North Little Rock Planning Commission
June 9, 2026 - Agenda / Public Hearing 4:00 PM
City Council Chambers – 300 Main Street, NLR, AR 72114

**North Little Rock Planning Commission
Minute Summary
May 12, 2026**

GEO HEILMANS ADDITION
NORTH LITTLE ROCK, PULASKI CO., AR
FOR J & K
LANDSCAPE PLAN

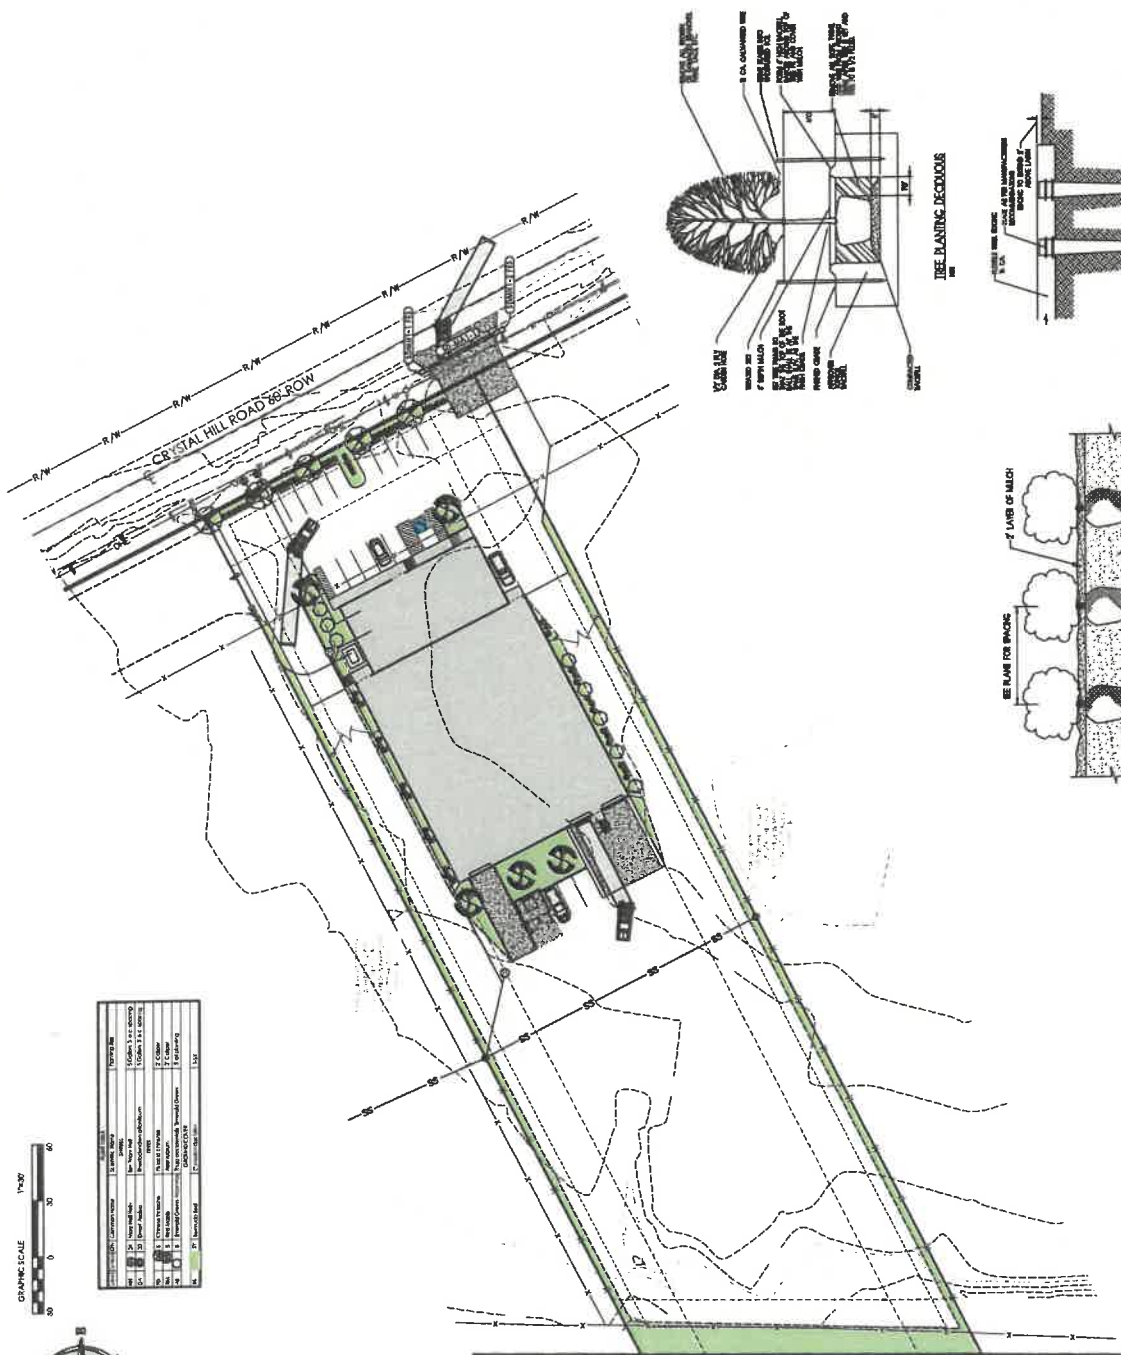
- b. Any new site development must comply with the City's minimal landscape and buffer ordinance requirements.
 - c. Planting plan as submitted is acceptable.

- d. With the exception of tree caliper specification. To meet the minimum code requirements revise all trees to meet the minimum caliper of 2.5 inches.

- e. Landscape plan to be revised prior to the June 2026 Planning Commission Hearing
8. Meet the following requirements concerning signage:
 - a. All signs require a permit and separate review.
